Meeting Date:	June 15, 2022	Meeting Title:	Planning Commission
Submitting Department:	Planning Department	Presenter:	Tyler Valentine
Agenda Item:	P22-071 Development Plan for a new 3-story, mixed-use building at the properties addressed at 50 S. Cache Street and 45 & 75 E. Pearl Avenue	Public Comment:	No

Town of Jackson
Project Plan Review History
PLANNING

Project Number	P22-071	Applied	3/30/2022	AL
Project Name	Dev. Plan - 50 S Cache, 45 & 75 E Pearl	Approved		
Type	DEVPLAN	Closed		
Subtype		Expired		
Status	STAFF REVIEW	Status

B. PEDESTRIAN BOARDWALK

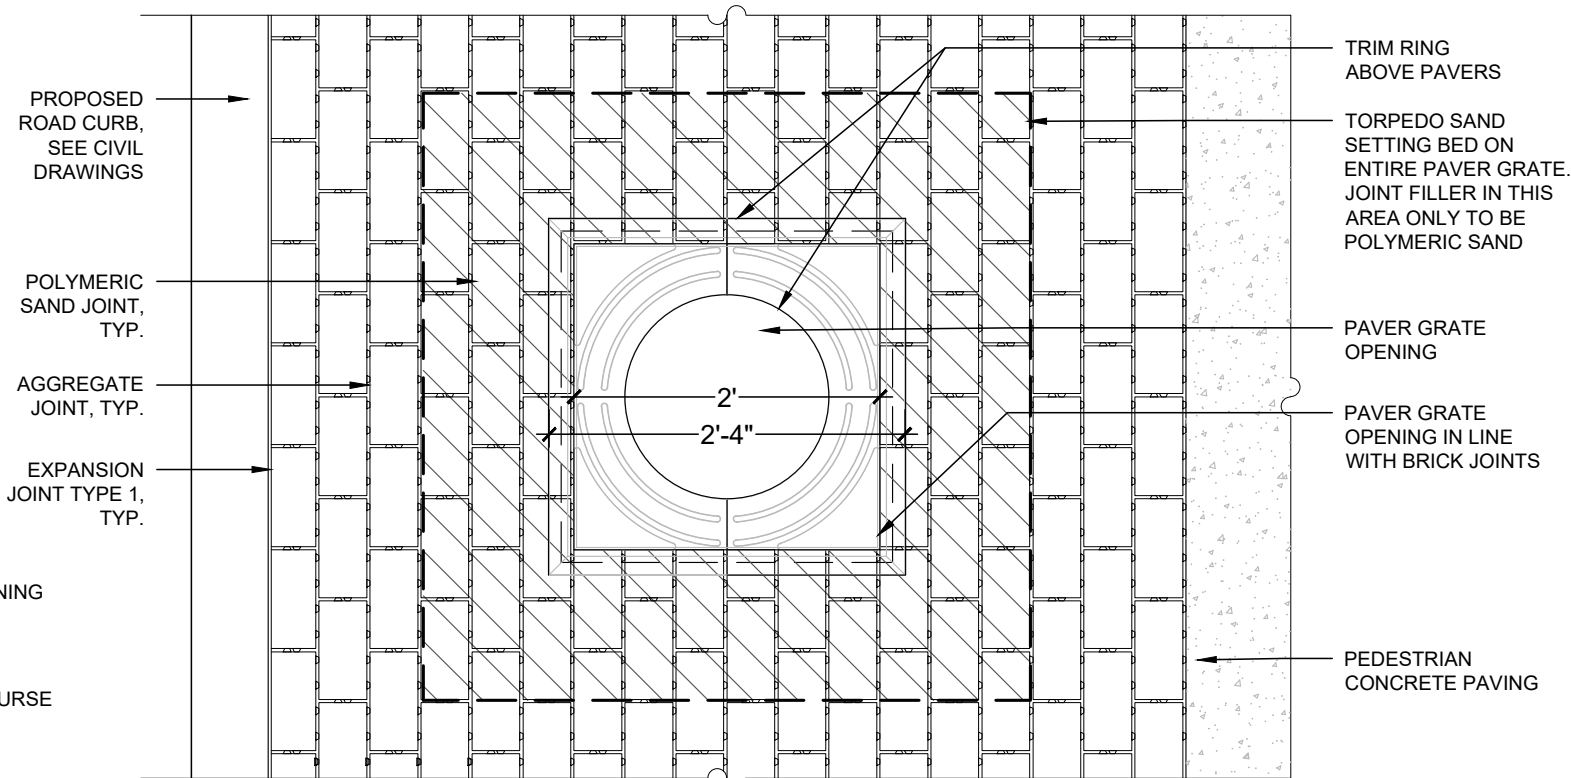
26. Hydronics are not permitted in the Public ROW. SHEET 57 of 160, Detail A, Pedestrian Concrete details snowmelt system w/tubing.				
27. Plans show old boardwalk detail, B. Pedestrian Boardwalk, use rustic boardwalk detail.

DRAWING NO
C1.1
JOB NO
21-076-03

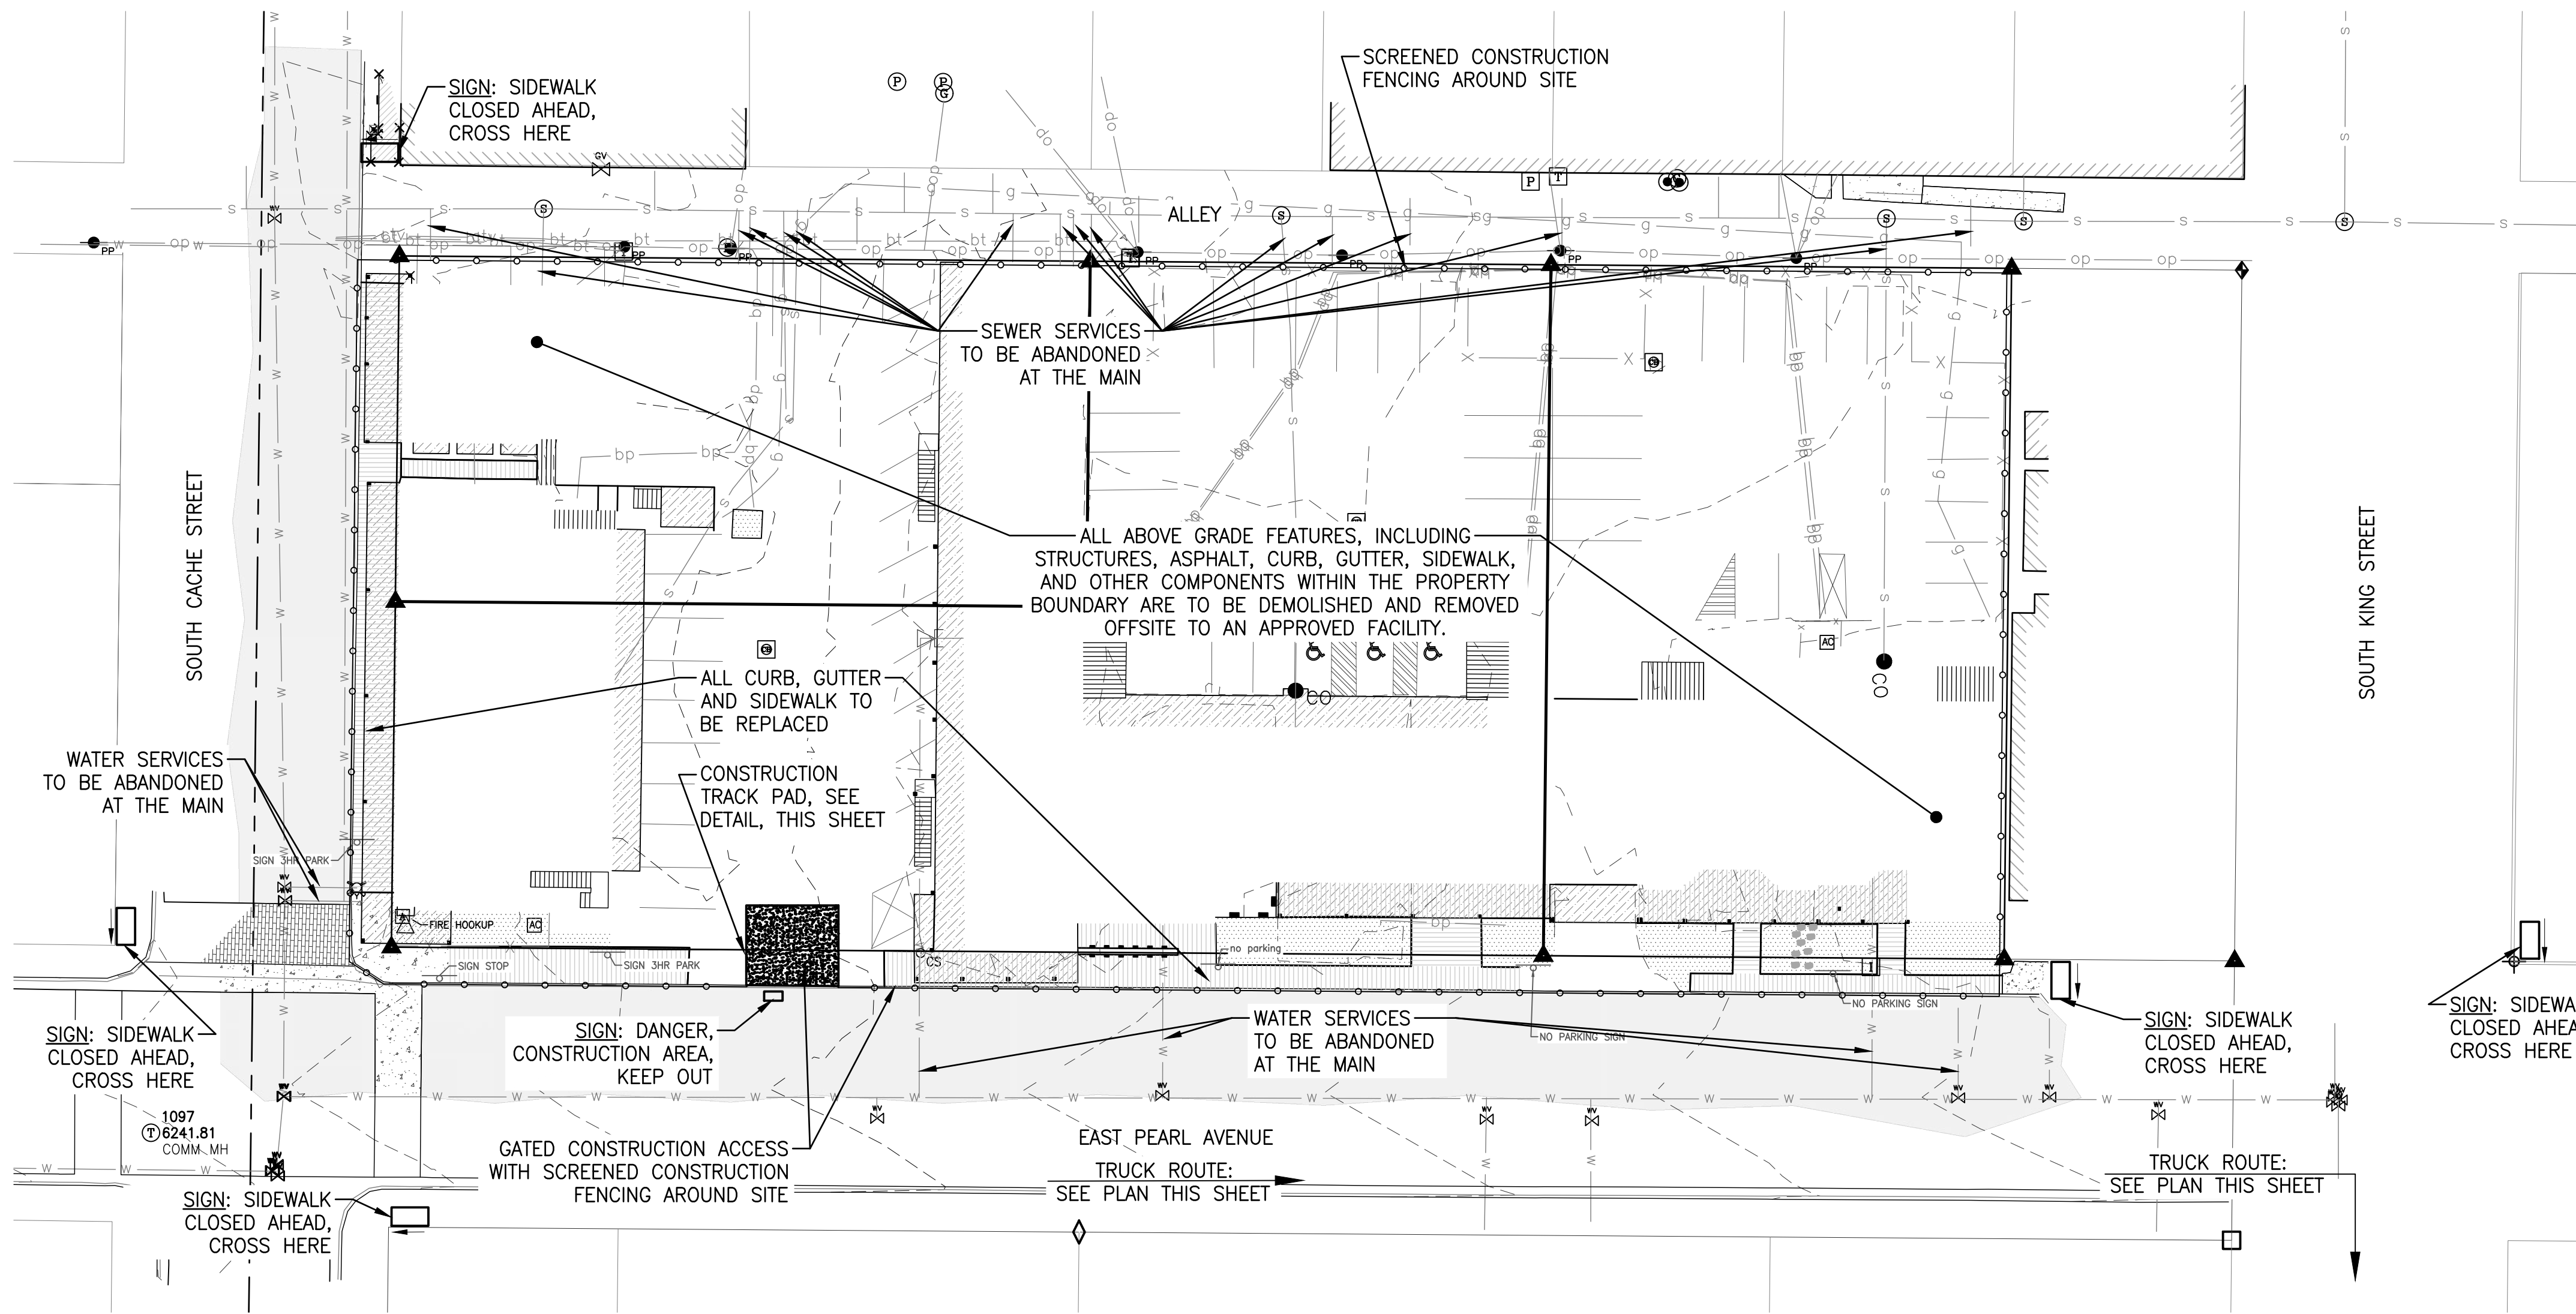
39. Requires WYDEQ Small Construction permit along with a SWPPP.				
40. Revise proposed truck route during the demolition phase. ToJ would prefer loaded trucks to travel on Pearl Avenue rather than the route shown on Sheet C1.1.
